**HUMER KWER HEALTH CENTER
SULAYMANIYAH, IRAQ**

SUSTAINMENT ASSESSMENT

**SIGIR PA-09-186
APRIL 20, 2010**

Summary of Report: PA-09-186

**Figure 1. Humer Kwer Health Center project site plan
(Courtesy of GRN)**

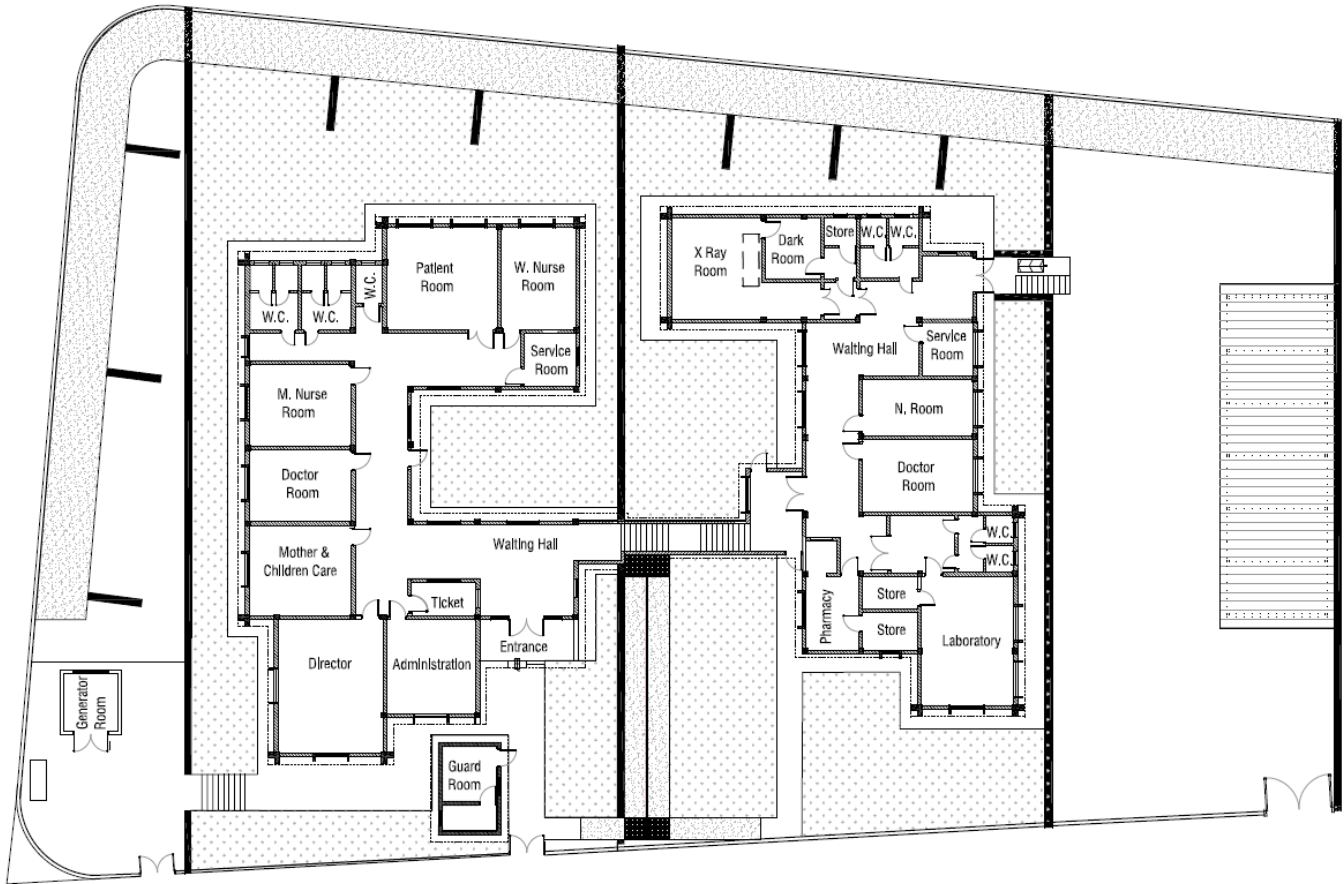
Actual construction plans differed from the conceptual site plan. The conceptual site plan was developed without the benefit of accurate topographic information for the project. Elevations shown on the conceptual site plan indicated a proposed level pad for the building and parking with only 0.20 meters of elevation change across the site. The contractor performed a topographic survey of the site to determine the actual site elevation differential. Based on the topographic survey, the actual differential in elevation across the site is approximately 18 meters. The contractor's site plan indicated the use of retaining walls to terrace the site. The building was shown on two separate levels with parking on a third level. The contractor's site plan shows the project construction within a 3,000 square meter area (Figure 1).

An exterior ramp is shown connecting the upper and lower levels of the building. The ramp is fairly long, and contains one intermediate landing. The design slope for the ramp is 10%. This is a difficult grade for handicapped individuals to traverse.

**Figure 2. Steel fence secured to retaining wall
(Courtesy of GRN)**

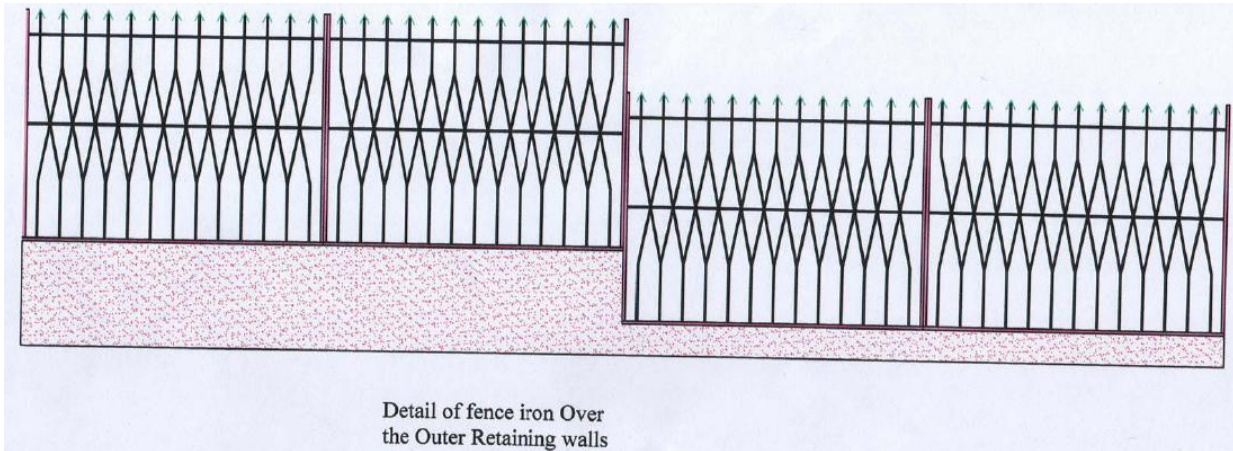
The perimeter security wall details provided with the conceptual design drawings included details for the concrete masonry unit⁴ (CMU) wall, foundation, and reinforcement for the gates and is identical on the contractor's drawings. In several areas the need for a retaining wall precludes the construction of a CMU security wall. In these areas, the contractor proposed a steel fence mounted to the top of the retaining wall (Figure 2).
